9 St. Martins Almshouses
NW1 0BD
Basement Impact Assessment
Audit

For
London Borough of Camden

Project Number: 12466-97
Revision: D1

October 2017

No. 7 St. Martin's Almshouses– Potential Damage Calculations in Stiff Clay

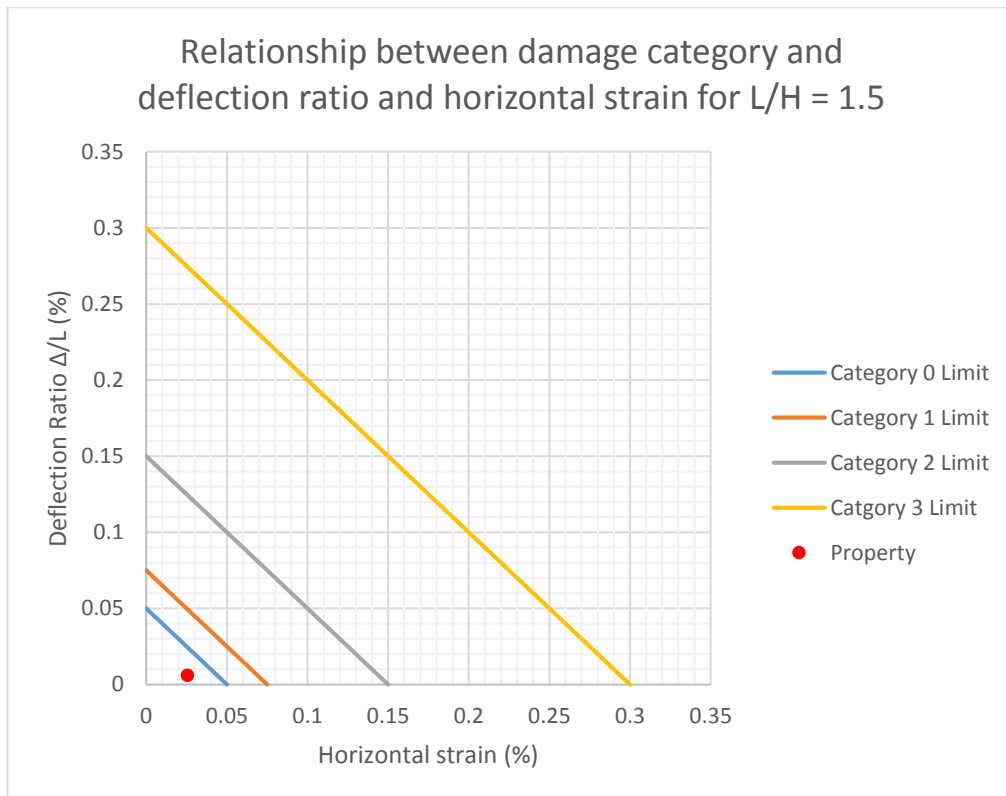
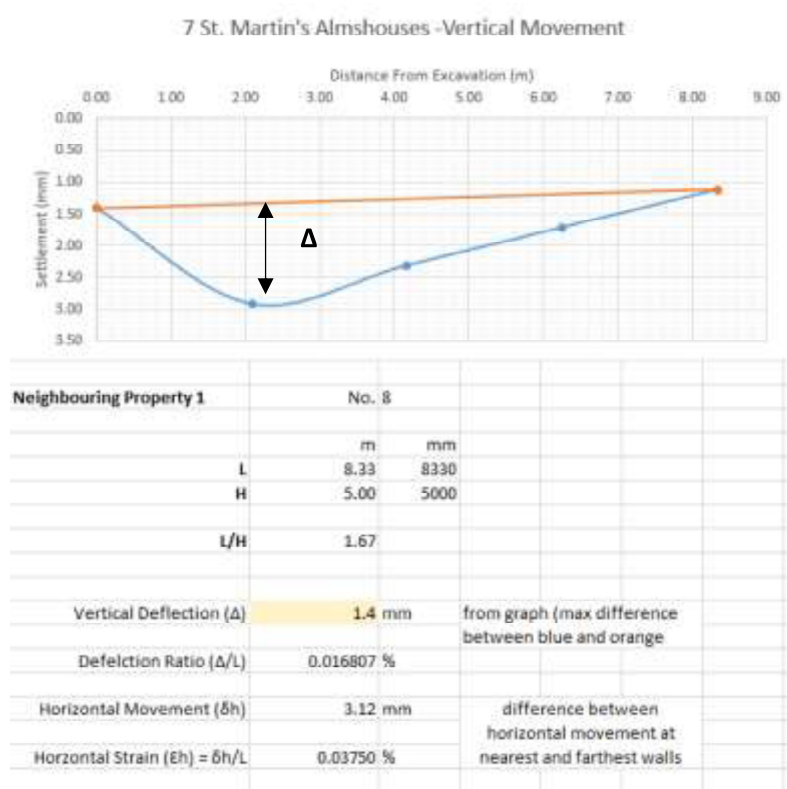
- 4.14. The GMA does not appear to have summed the vertical movements from both installation and excavation correctly, with a maximum vertical movement of 3mm plotted which would approximately equate to the vertical movement due to excavation alone (for number 7 St Martins Almshouses). Clarification is required for No 7 which appears to have been confused with number 8. For this reason the GMA should be revised and reissued together with the revised. It should be noted that the maximum permissible damage category is 1.

- 5.8. The GMA does not appear to have summed together the vertical movements from both installation and excavation correctly. The GMA should be revised and reissued.

Query No	Subject	Query	Status	Date closed out
1	Stability	Clarification of new rear extension ground floor form of construction.	Open	
2	Stability	GMA to be revised to account for cumulative movements caused by installation and excavation.	Open	
3	Stability	Retaining wall calculations to account for surcharge of neighbouring extension	Open	
4	Hydrology	Mitigation measure to be proposed (SUDS) due to increased discharge to sewer system	Open
